Federal Register

Wednesday, December 3, 2003

[Docket No. 2003-NE-52-AD; Amendment 39-13381; AD 2003-24-12]

Airworthiness Directives; Pratt & Whitney JT9D-3A, -7, -7A, -7F, -7H, -7AH, and -7J Turbofan Engines

Figure 1

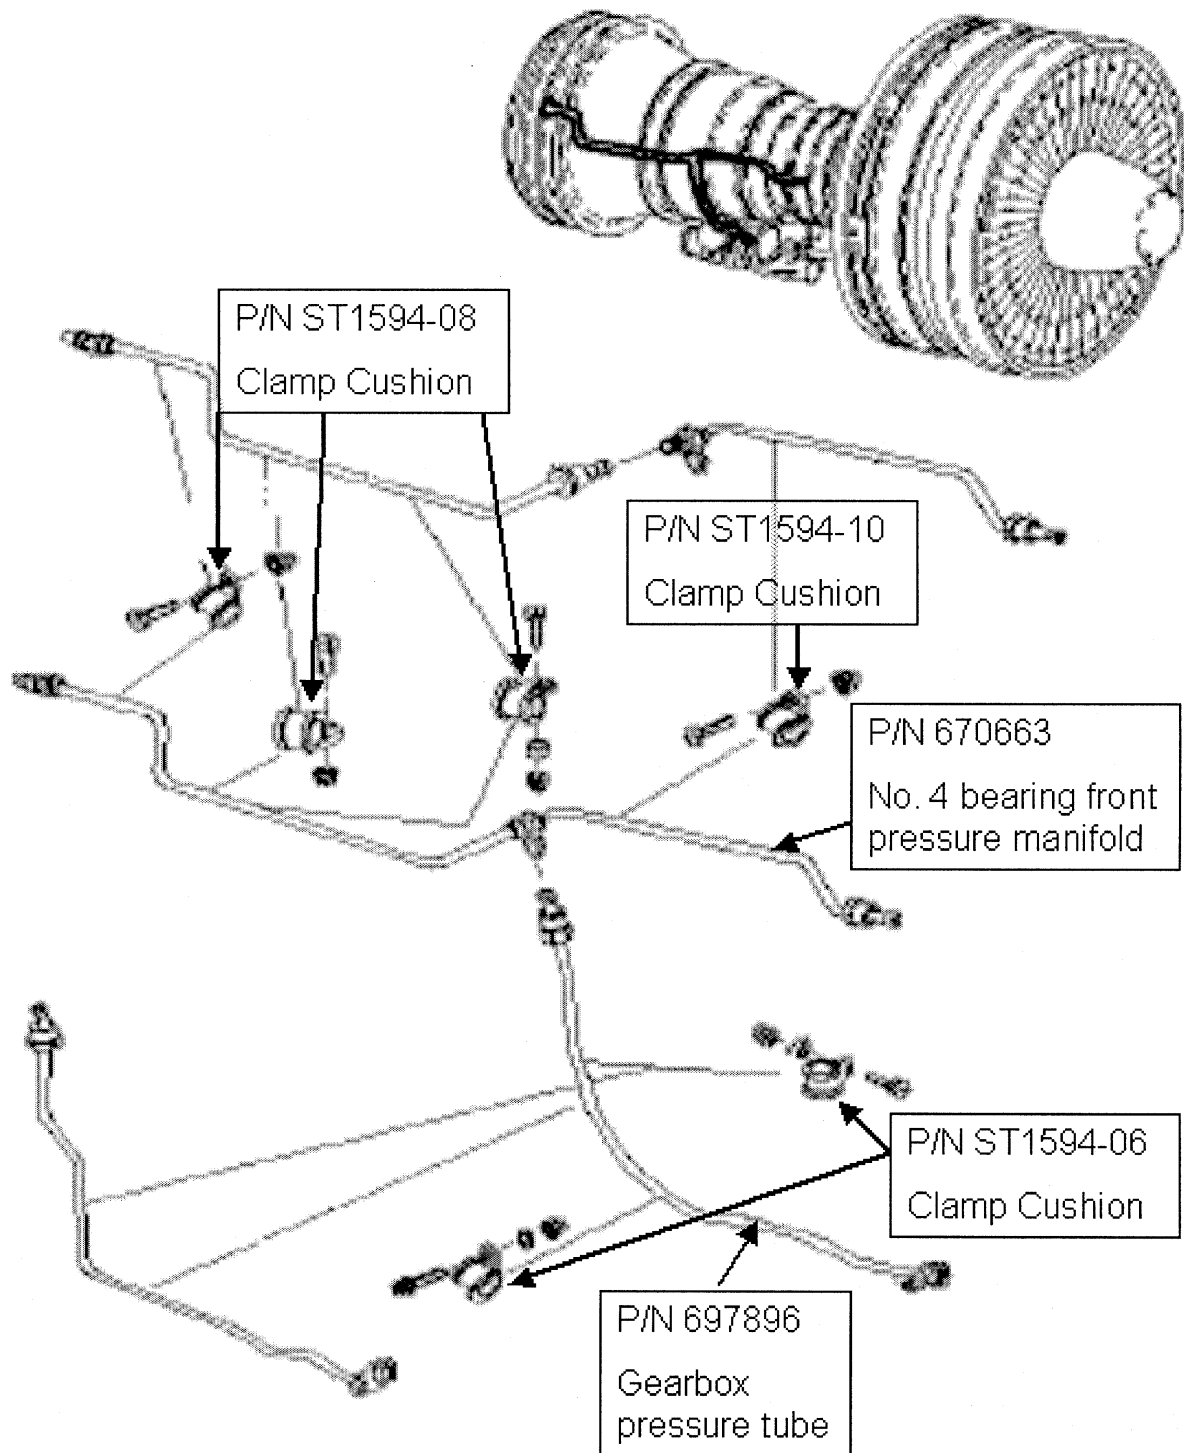
(h) If the gearbox pressure tube, No. 4 bearing front pressure manifold, or clamp assemblies are not properly positioned, then correctly position them before further flight, as shown in the following Figure 1 of this AD.
